APPLICATION NO.	FILING DATE	FIRST NAMED INVENTOR	ATTORNEY DOCKET NO.	CONFIRMATION NO.
10/587,029	07/24/2006	Masahiro Orita	Q96124	9255
65565 7590 11/20/2009 SUGHRUE-265550		9	EXAMINER	
2100 PENNSYLVANIA AVE. NW			GREEN, TRACIE Y	
WASHINGTON, DC 20037-3213			ART UNIT	PAPER NUMBER
			2879	
			NOTIFICATION DATE	DELIVERY MODE
			11/20/2009	ELECTRONIC

#### **DETAILED ACTION**

### Response to Amendment

FIG. 2E

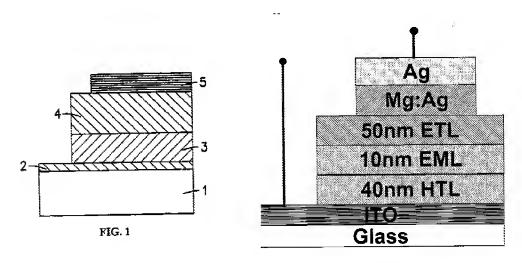
Regarding claim 1, Bulovic teaches (figures 1-9) (Examiner has reproduced Figures 1 and 2e for applicant's reference) a quantum dot-dispersed light emitting device comprising (¶36 and 39) (Examiner note: In the disclosure prior art refers to nanoparticles, -dots and -crystal which behave as quantum dots; furthermore figures 3-6, represent the nanocrystals by "QD" signifying their behavior): a substrate (1); an electron injection electrode (5, Fig 2e, Mg); a hole injection electrode (2, Fig 2. ITO); and an inorganic light emitting layer (EML) disposed so as to be in contact with both the electrodes (1,2), wherein the inorganic light emitting layer (EML) includes an ambipolar inorganic semiconductor material and nanocrystals ((¶33, lines 1-3 and ¶39, lines 7-12) (Examiner note: prior art discloses GaP, GaAs, GaSb, GaSe, InN, InP with CdS, CdSe, CdTe at the core) dispersed as luminescent centers (¶33, lines 1-3) in the ambipolar inorganic semiconductor material (¶39, lines 7-12), and is configured without having, at the interface with the electron injection electrode and/or the hole injection electrode, epitaxial relation therewith (¶48, lines teaches dispersion in matrix material) Regarding claim 4, Bulovic teaches wherein the inorganic light emitting layer comprises a ZnS type semiconductor phase (¶39, lines 7-12) (prior art reveal this can be used)

**Regarding claim 9,** Bulovic teaches wherein the electron injection electrode (5) and the hole injection electrode (2) are disposed spaced apart from each other, with the inorganic light emitting layer (EML) interposed there between, in a lamination on the substrate (1).

**Regarding claim 10,** Bulovic teaches wherein the electron injection electrode (5) and the hole injection electrode (2) are disposed spaced apart from each other in a plane on the substrate (1). (*Examiner note: in they are spaced apart in the y-plane and x plane*
